Docket Number:	23-AFC-02
Project Title:	Elmore North Geothermal Project (ENGP)
TN #:	254078
Document Title:	Cover Letter with CURE Data Requests Set 4
Description:	N/A
Filer:	Alisha Pember
Organization:	California Unions for Reliable Energy
Submitter Role:	Intervenor
Submission Date:	1/22/2024 4:28:23 PM
Docketed Date:	1/22/2024

**Re: CURE Data Requests Set 4 for Elmore North Geothermal Project
(23-AFC-02)**

CALIFORNIA UNIONS FOR RELIABLE ENERGY
DATA REQUESTS SET 4

**ELMORE NORTH GEOTHERMAL PROJECT
CURE Data Requests Set 4 (Nos. 255-287)**

Figure 1. Revised Project boundaries. Laydown area and injection well that occur outside of the BSA are circled in red.

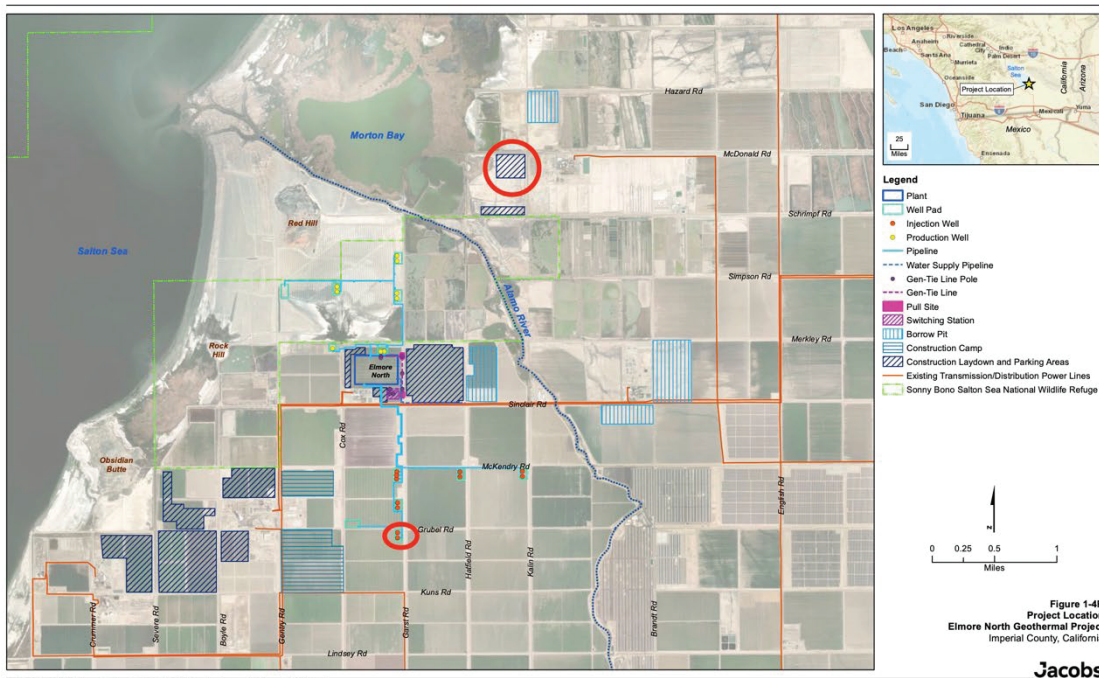
The revised Project boundaries are shown in Figure 1-4R of the Elmore North Geothermal Project Revised General Arrangement Refinement Package. (TN 253187) The Project now proposes a laydown area and an injection well in two locations outside of the BSA, which are depicted within red circles in Figure 1. Information on the land cover types and aquatic resources within the updated Project boundaries has not been provided.

276. State whether biological resource surveys were conducted within the revised Project boundaries in Figure 1-4R that are outside of the BSA boundaries in AFC Figure 5.2-4.

277. If surveys were conducted in response to Data Request No. 269, please describe the survey methods and resources that were surveyed.
278. Provide a map that identifies the land cover and vegetation types within the revised Project boundaries in Figure 1-4R.
279. Provide a map that identifies the aquatic resources within the revised Project boundaries in Figure 1-4R.
